CHAPTER 23.45 LOCAL AMENDMENTS TO THE INTERNATIONAL FIRE CODE

The amendments to the International Fire Code (IFC) are listed hereinafter by Section. The edition adopted is as listed in AMC 23.05.010. The structure of amendments is as explained in AMC 23.05.015.

FIGURE D103.1 DEAD-END FIRE APPARATUS ACCESS ROAD TURNAROUND

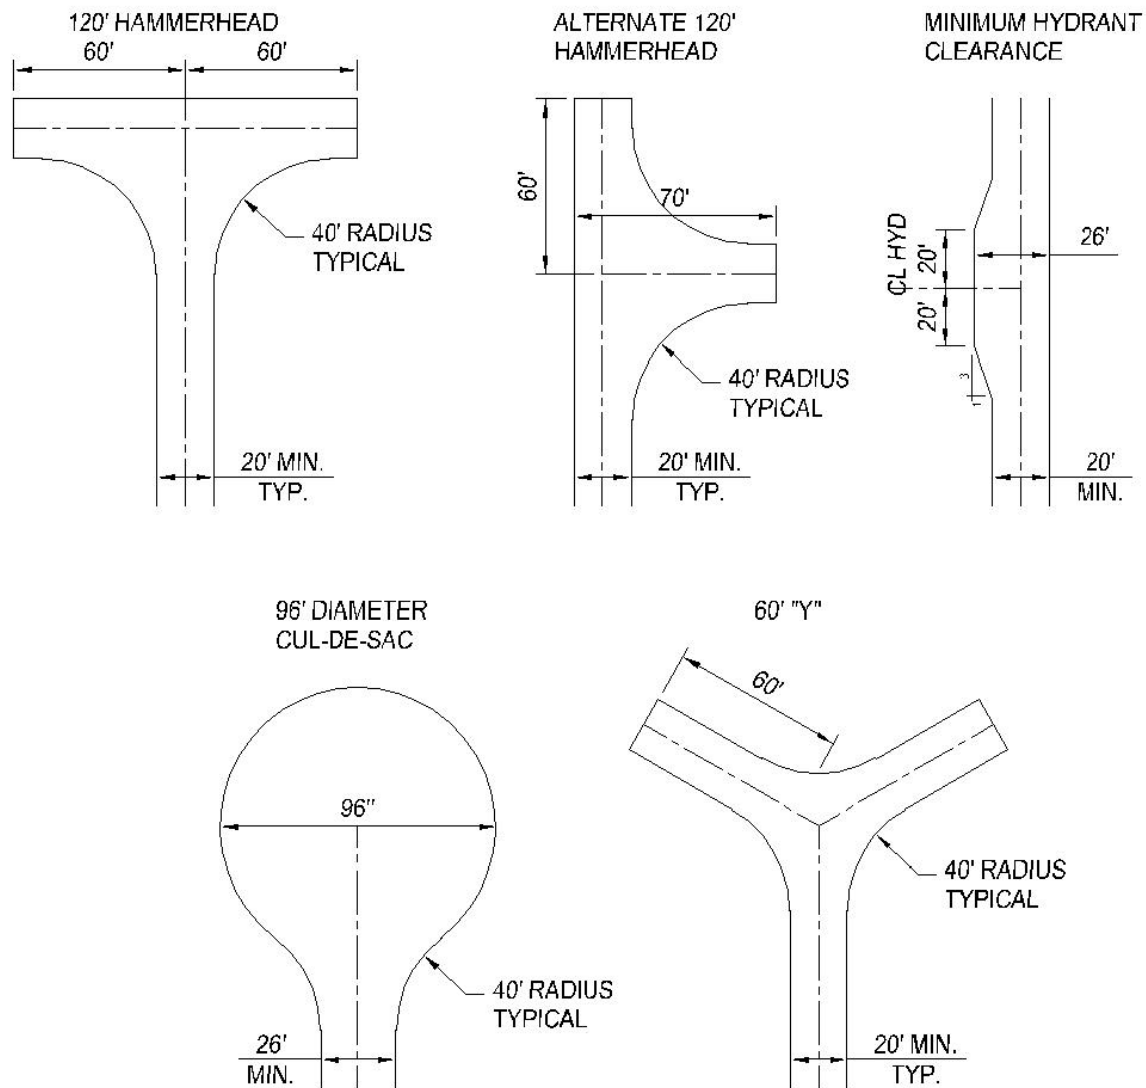
Delete Figure D103.1 and replace with the following figure:

NOTE: 20' WIDTH MAY BE REDUCED TO 12' WIDTH FOR RESIDENTIAL DRIVEWAYS
